THE ARBORS

The plat illustrates the proposed 48-lot, 18.8± acre subdivision which is located on the West side of McFarland Road, 470'± South of McFarland Way. The subdivision is served by city water and sanitary sewer.

The purpose of this application is to create a 48-lot subdivision from two metes and bounds parcels.

DETAIL SITE PLAN

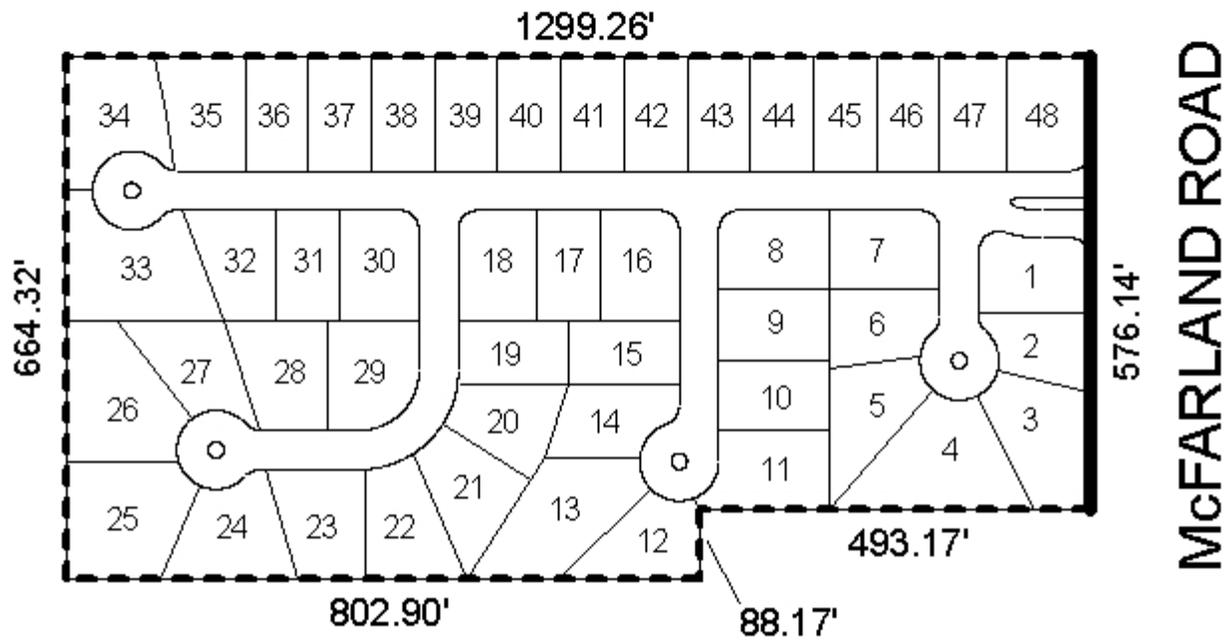
As a means of access management, a note should be placed on the final plat stating that Lots 1-3 and 48 are denied direct access to McFarland Road. Additionally, as illustrated on the plat, a note should be placed on the final plat stating that Lots 1, 7, 8, 16, 18, 29, and 30; which are corner lots should be restricted to one curb cut.

As illustrated on the preliminary plat there are several areas of property located in the center of the proposed cul-de-sacs, and between the entrance right-of-way from McFarland Road that are not labeled as common areas. These areas should be labeled on the final plat with a note stating that maintenance of all common areas are the responsibility of the property owners association.

The required twenty-five foot minimum building setback lines are not illustrated, but will be required on the final plat.

With modifications, the plat will meet the minimum requirements of the Subdivision Regulations and is recommended for Tentative Approval subject to the following conditions: 1) placement of a note on the final plat stating that Lots 1-3, and 48 are denied access to McFarland Road; 2) the placement of a note on the final plat stating that all corner lots are limited to one curb cut each, with the size, design and location to be approved by County Engineering; 3) the placement of a note on the final plat, stating that a buffer, in compliance with Section V.A.7., will be provided where the site adjoins residentially developed property; 4) all common areas be indicated on the final plat, and a note on the final plat stating that maintenance of all common areas are the responsibility of the property owners association; and 5) placement of the required 25-foot minimum building setback line on the final plat.
